DRAINAGE PLAN

RESPONSE TO 1/23/95 COA COMMENTS

GRADING AND DRAINAGE PLAN

BRUNCINI WAREHOUSE

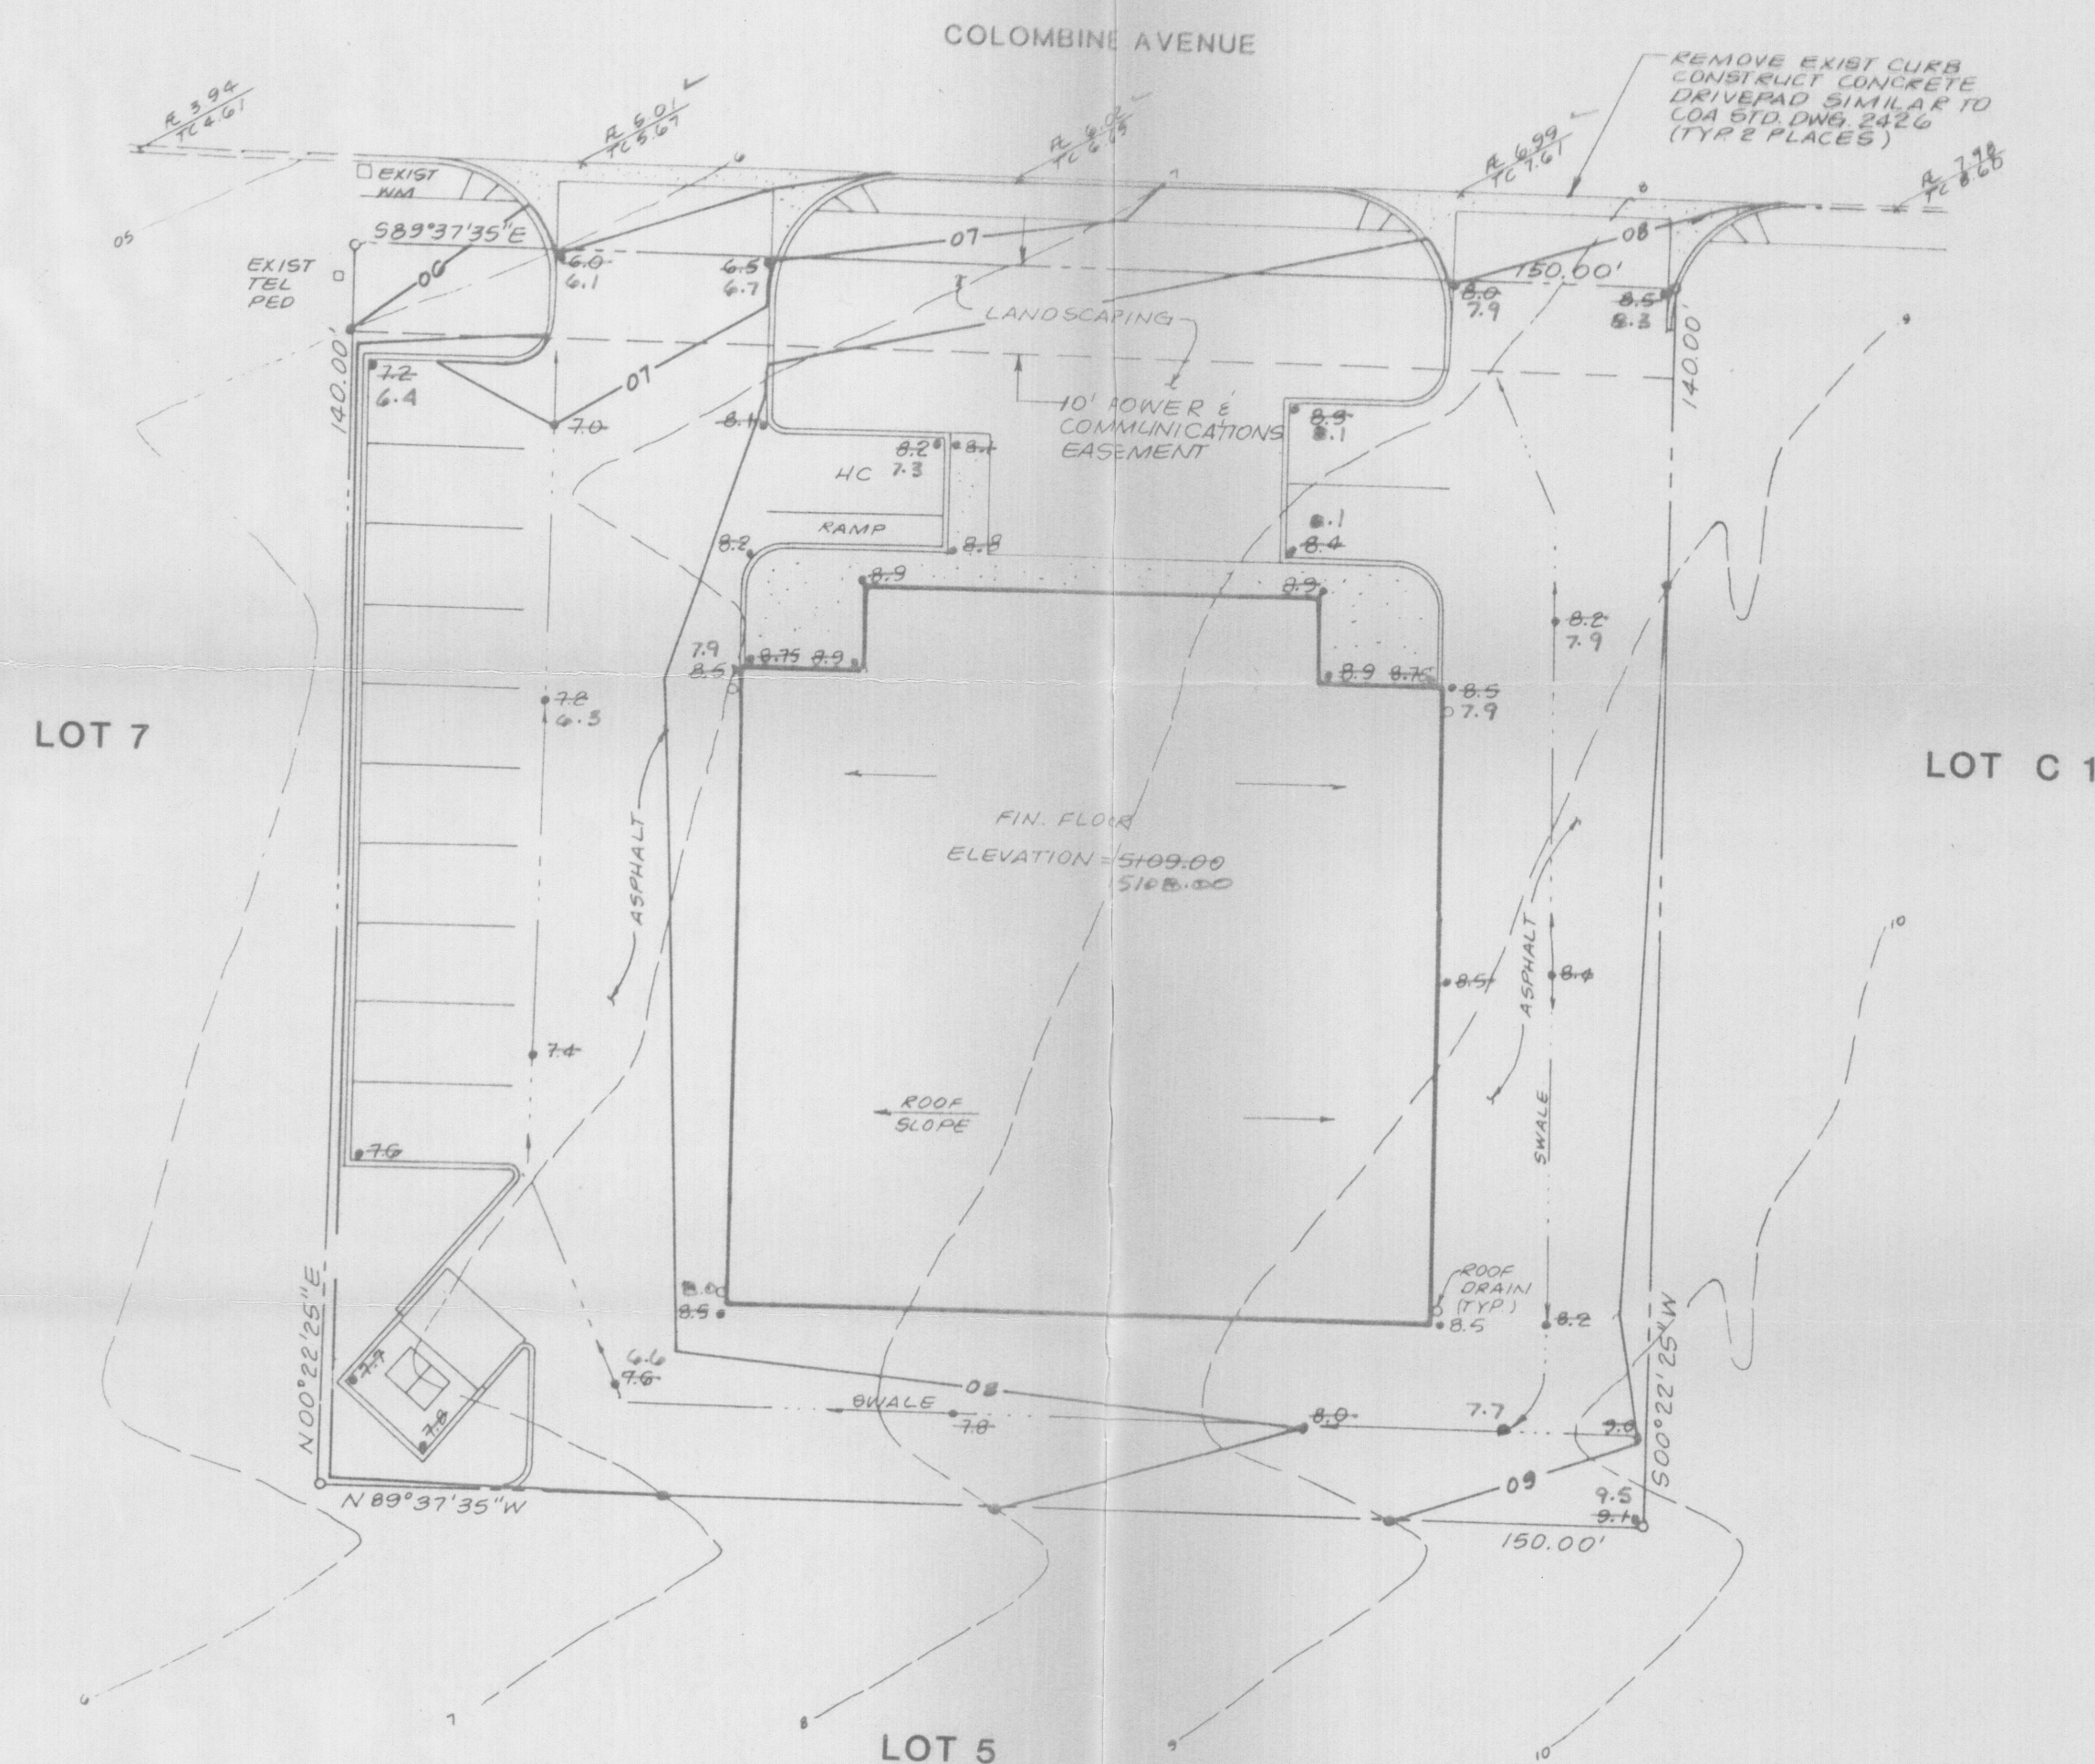
1. THE FEMA MAP INDICATES THE PRESENCE OF A 100-YEAR FLOOD BOUNDARY THROUGH A PORTION OF THIS PROPERTY. THE INFRASTRUCTURE CONSTRUCTED DURING THE SUBDIVISION OF THIS PROPERTY HAS ALTERED THE FLOOD BOUNDARIES. FLOOD PROOFING HAS NOT BEEN PROVIDED. UNTIL REVISIONS ARE MADE TO THE FEMA MAP, THIS PROPERTY MAY BE SUBJECT TO FLOOD INSURANCE REQUIREMENTS.
2. THE DRAINAGE MASTER PLAN FOR THE RICHFIELD SUBDIVISION IS TITLE "DRAINAGE REPORT FOR RICHFIELD PARK" BY ESPEY, HUSTON & ASSOCIATES, INC, AUGUST 1986. THE REPORT DOES NOT USE THE "NEW" HYDROLOGY.
3. A REVIEW OF THE SITE AND THE TOPOGRAPHY INDICATE SWALES TO THE EAST AND SOUTH THAT ROUTE OFF SITE FLOWS AWAY FROM THE SITE.
4. ADJACENT LOTS AND EASEMENTS HAVE BEEN LABELED.
